Item 4
39-41 College Street, Gladesville - LDA2021/0394
Demolition of existing industrial buildings and construction of an industrial unit complex with associated parking and landscaping

**City of Ryde
Local Planning Panel Report**

DA Number	LDA2021/0394
Site Address & Ward	39-41 College Street, Gladesville Lots 2 and 3 within DP 27462 East Ward
Zoning	IN2 Light Industrial under RLEP 2014
Proposal	Demolition of existing industrial buildings and construction of an industrial unit complex comprising 49 industrial units with mezzanine offices with associated parking and landscaping
Property Owner	Ms P J Smith, Mr B A Wilson and Mr J B Wilson
Applicant	Level Architects
Report Author	Kimberley Kavwenje – Senior Coordinator Development Assessment
Lodgement Date	12 November 2021
No. of Submissions	None
Cost of Works	\$13,790,030.42
Reason for Referral to LPP	Departure from Development Standard The proposed development results in a 11.2% departure from the development standard for height of buildings imposed by Clause 4.3 of RLEP 2014. <i>Schedule 1, Part 2 of Local Planning Panels Direction</i>
Recommendation	Deferred Commencement Consent

Figure 14 Existing electrical easement

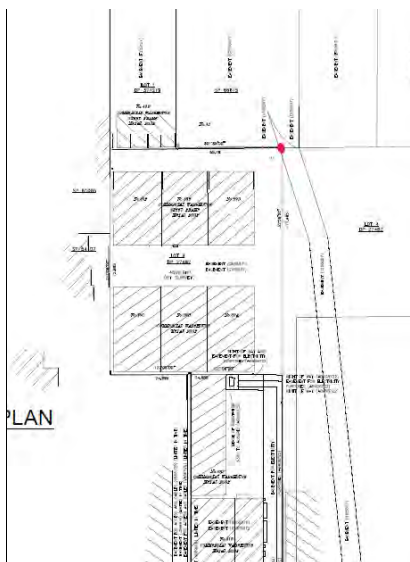
The proposal is recommended for a deferred commencement approval given the requirement for the extinguishment of the existing electrical easement at the rear of the site.

Figure 18 Natural ground level shown in red along south eastern elevation from College Street showing Warehouses 45 – 49 (ground floor) and Warehouse 23

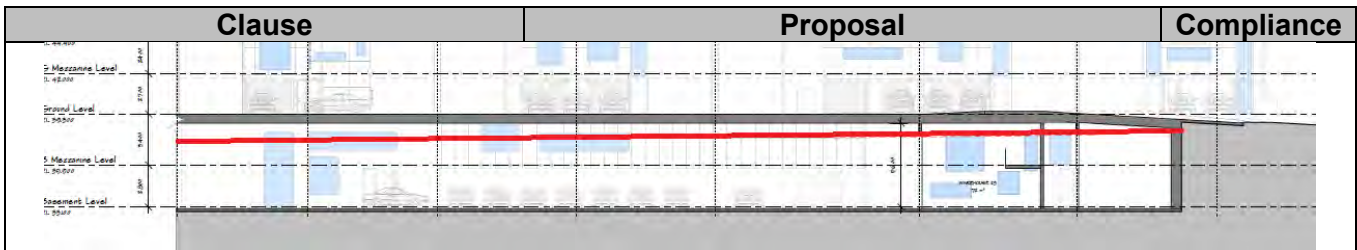
Clause	Proposal	Compliance
	<ul style="list-style-type: none"> - The proposal does create subterranean areas. The basement levels area for car parking only (with the exception of WC associated with warehouses 46 – 49) and the excavation does not contain implications for the amenity of these areas. - The internal north western elevation of warehouses and office sited along the south eastern elevation locate the offices within the entrance of the site to ensure openings are provided to the north eastern and south western elevations for increased amenity. - The basement mezzanine level also contains voids associated with the offices. The offices also contain openings to provide for increased amenity. - Noise, vibration and dust controls can be employed to ensure that any adverse impacts from the proposed excavation will be minimised. - Dilapidation surveys for neighbouring properties has been recommended. - All excavated material will be disposed of in accordance with the relevant requirements. - It is unlikely that the proposed excavation will disturb any relics. <p>As such, the development is consistent with the requirements of Clause 6.2</p>

Figure 21 Building height breach along the south eastern elevation at the rear of the site. The red lines notates the height exceedance and blue line represents the roof.

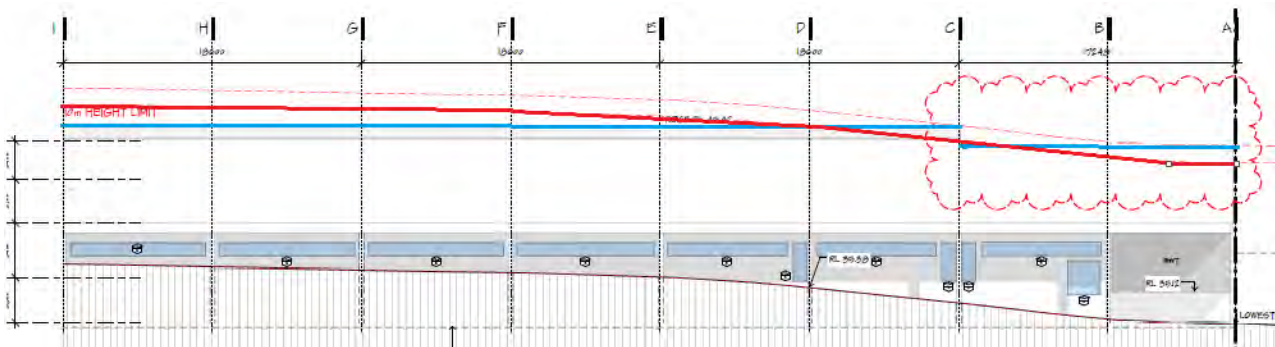
The height is calculated by Council as being 11.12 metres at the rear of the site (**Figure 21**). The proposal represents a 11.2% variation to the standard. The proposal also results in a height of 10.87m along the north western elevation (**Figure 22**) and exceeds the height standard. The rear elevation is shown in **Figure 23**.

Figure 27 Basement level

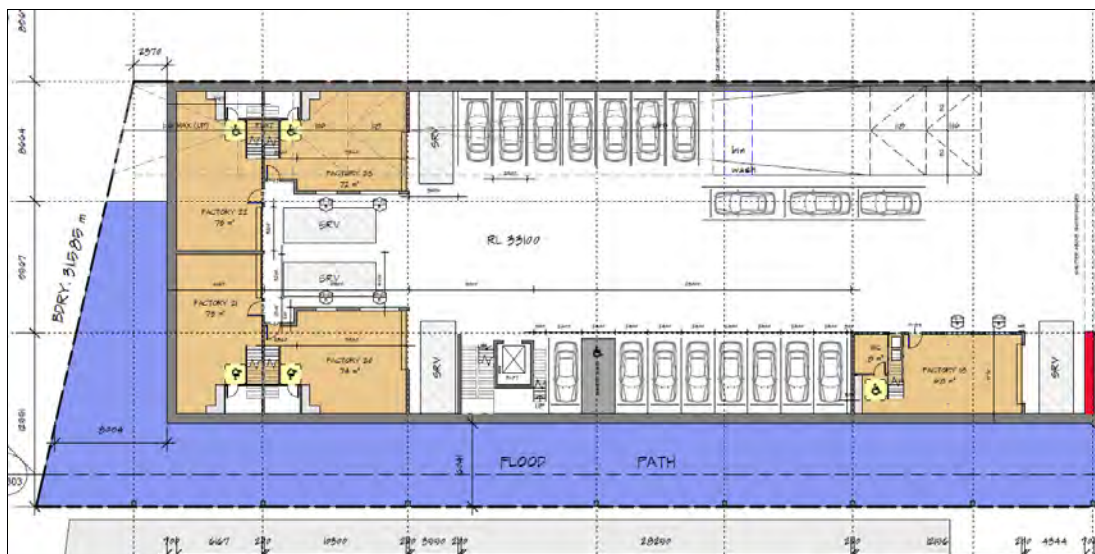
- SRV loading bays are proposed for the warehouses along the south western boundary (i.e warehouse 20-23), therefore, the internal roadways from the bottom of basement ramp to the warehouses along south western boundary should cater for a SRV passing a B99. In this regard, a swept path diagram shall be provided to Council for assessment to demonstrate a SRV can safely pass a B99 passenger vehicle at this location (**Figure 27**) from/to the basement ramp to/from the last warehouse (eg. Warehouse 21) along the south western boundary at basement level.

Figure 28 Identified cross section location request by Development Engineer shown in blue

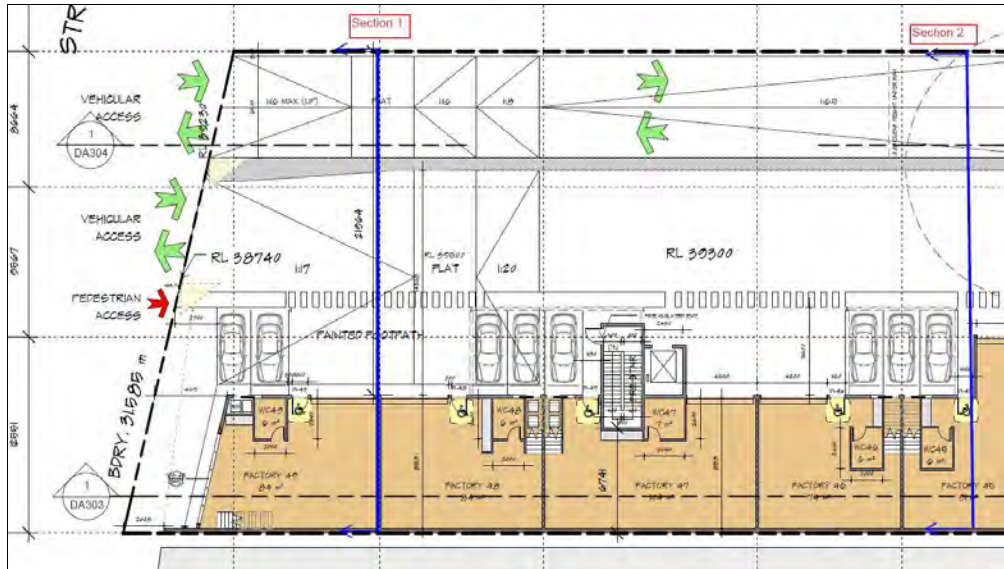
- It appears there are some openings or excavations below ground level to help the overland flow along the south eastern boundary, however, it is unclear what the proposed elevations are. In this regard, the applicant is to provide cross section profile at Section 1 and Section 2 marked in **Figure 27**.

Development Engineer’s review: The opening along south eastern boundary remains unchanged to maintain the existing water flow path and the natural ground level along the south eastern boundary is not proposed to change except the 200mm at the rear as per recommendation of the flood impact assessment report prepared by MBR Consulting Engineers (Project No.: MRB21100, Issue No.: B, Dated 22/03/2022).
